CMT SURVEYING AND CONSULTING INC.

February 9, 2023

Re: Incomplete Letter
Two-Lot Partition
MIP-22-06
2011 13th Street

APPENDIX A. EXISTING CONDITIONS AND PROPOSED PARTITION PLAT

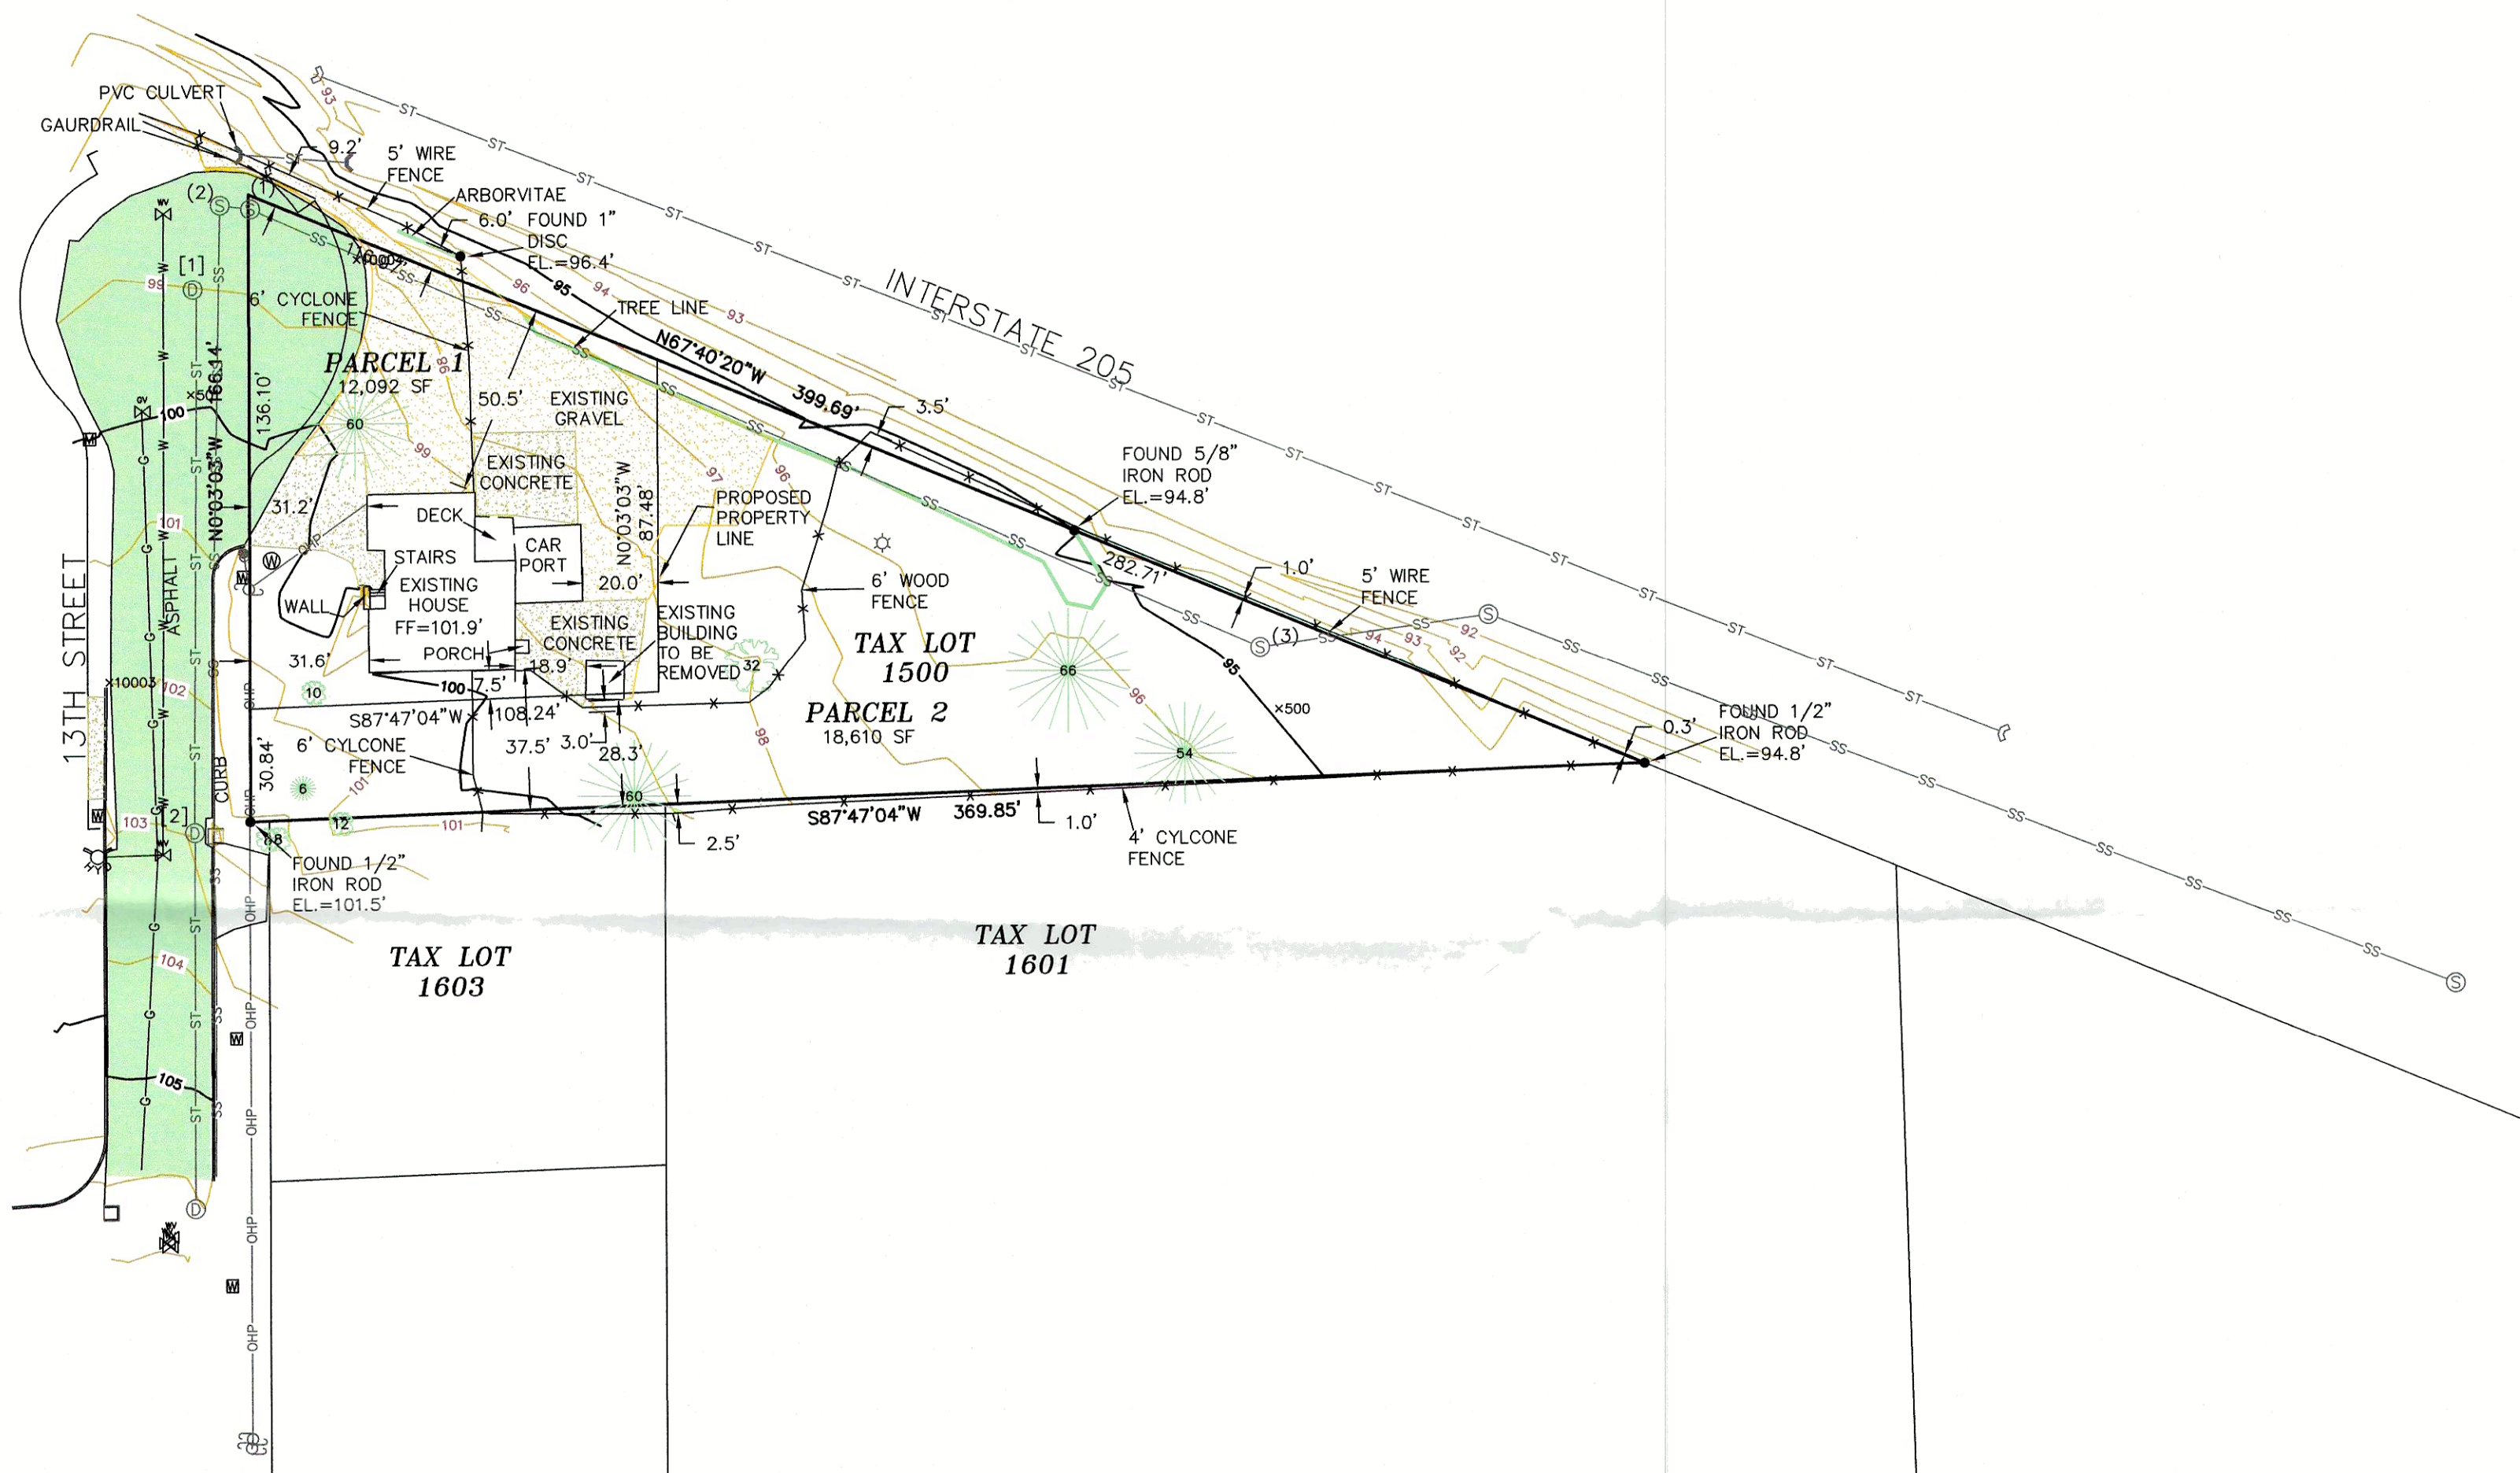
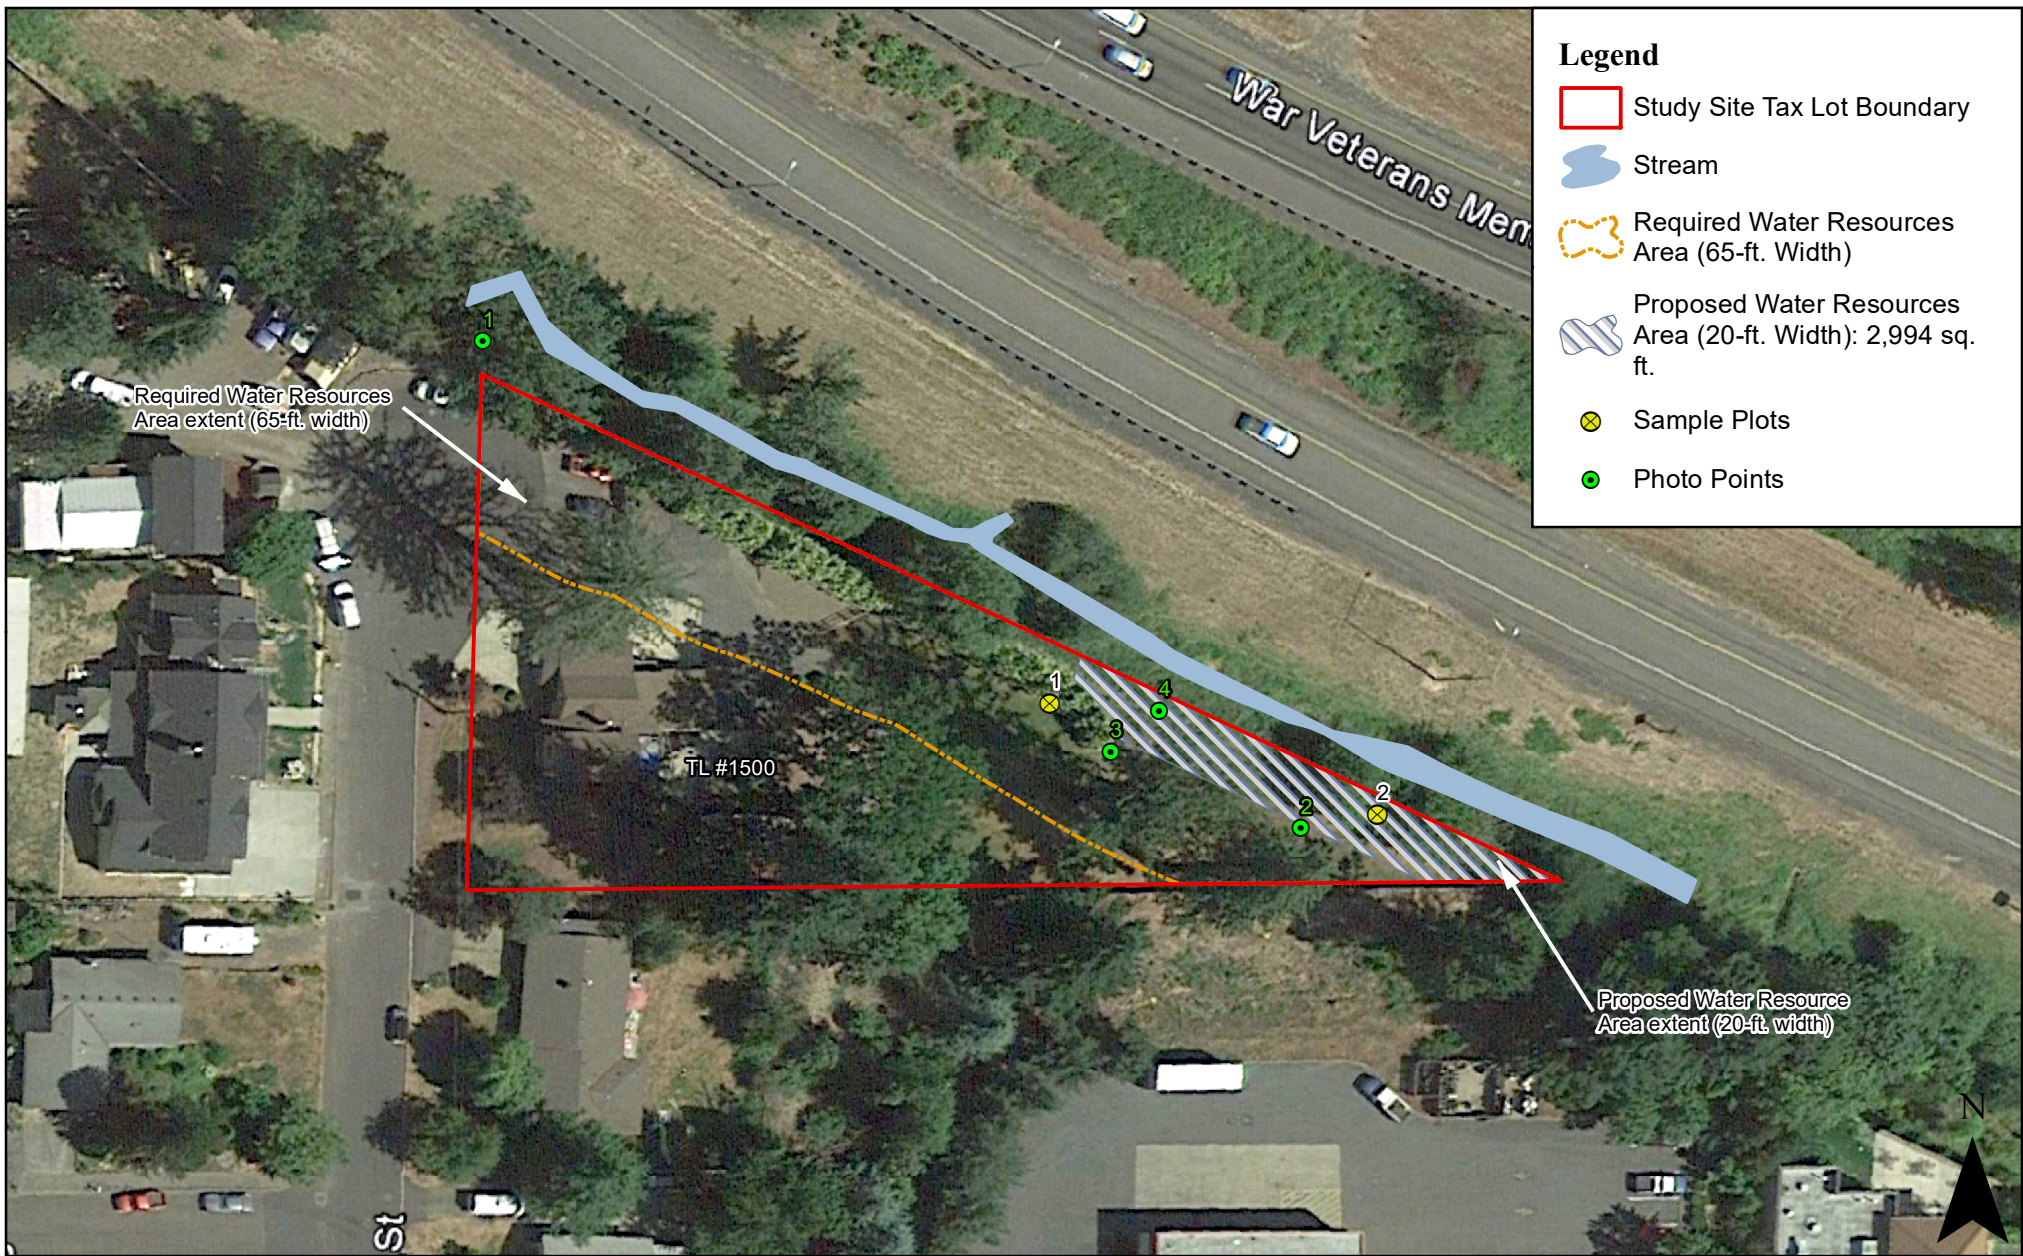
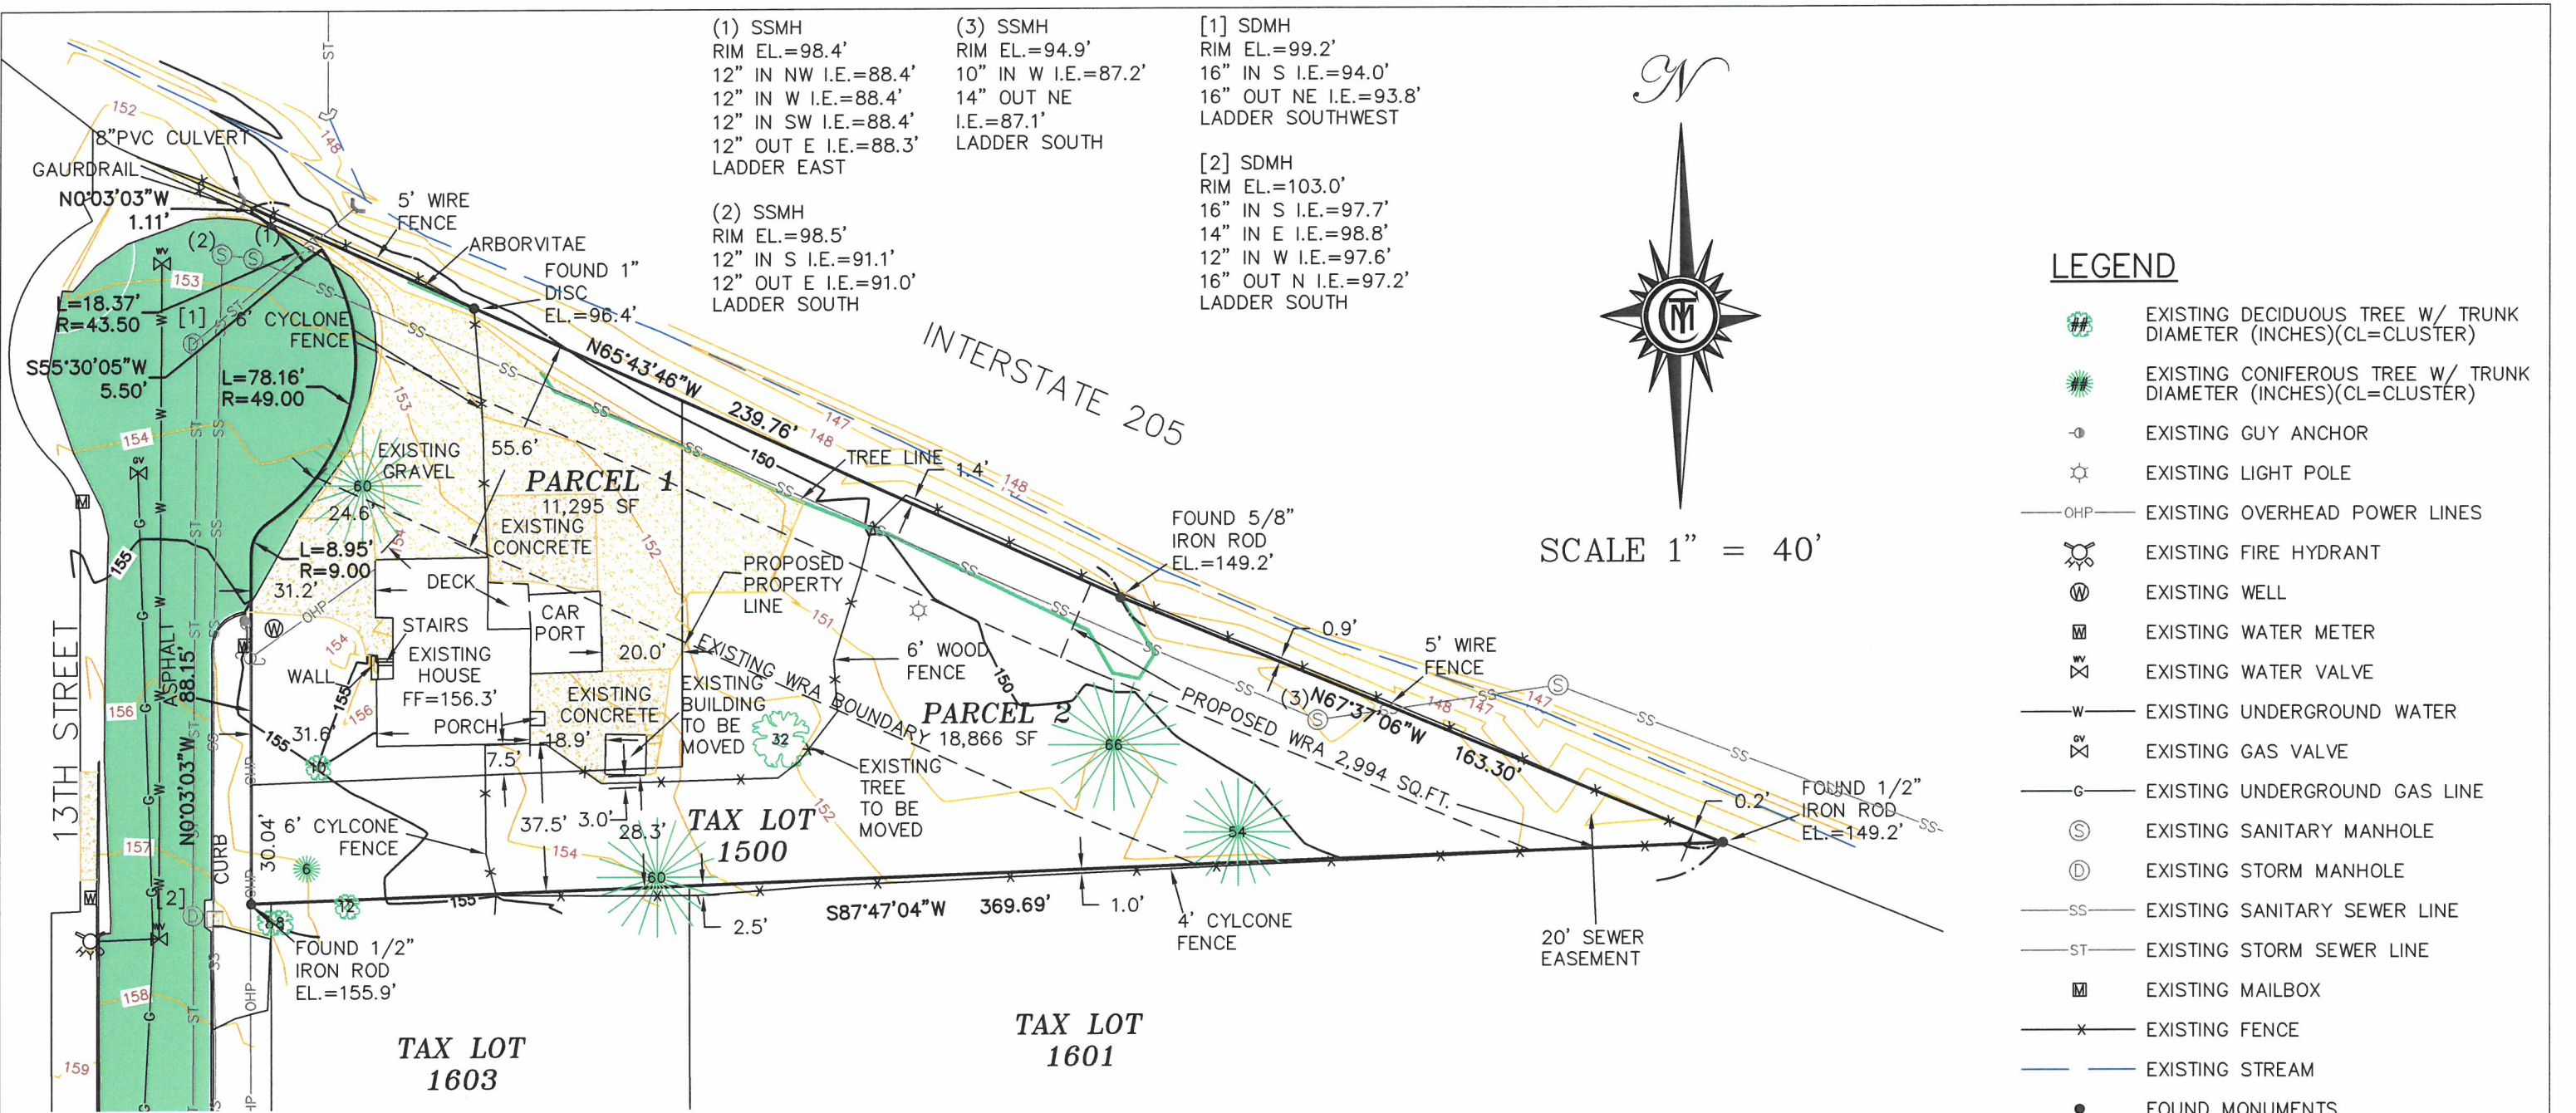
2. **Site Plan** – The Site Plan has been updated to include the existing WRA and the proposed WRA.
3. **Consultant Signature** – The consultant has now signed the Natural Resource Assessment document and a signed copy is included with this submittal.
